PROJECT No.: 0837-052

Meadowood Community Centre
1830 Galvin Place, Qualicum BC

ADDENDUM – 05

Item: **Services Enclosure**

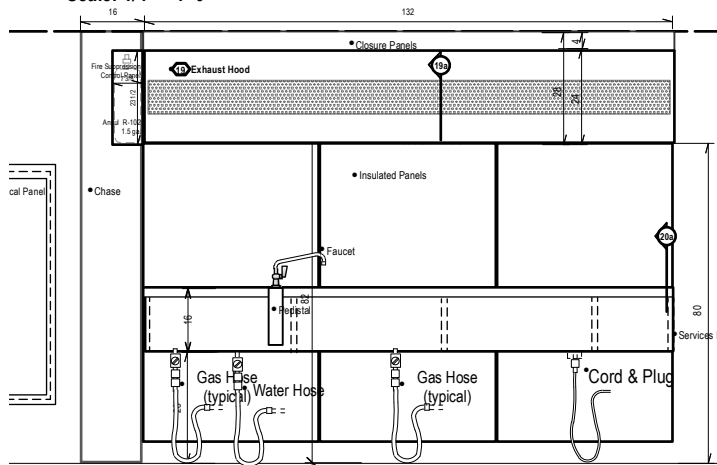
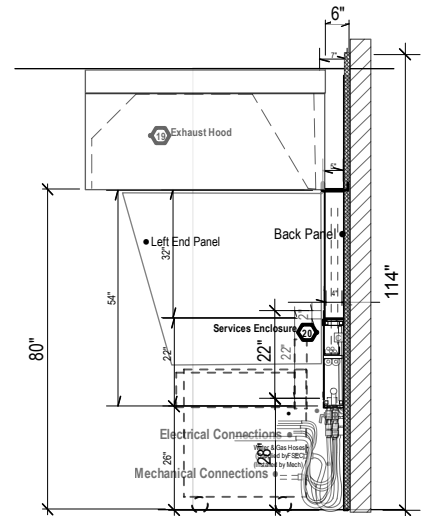
- 1.1. Refer to the attached drawings provided by GalleyWorks for the Kitchen equipment and layout
- 1.2. Correction to Door Schedule on Drawing A801: Doors D107 and D108 to be 4' wide
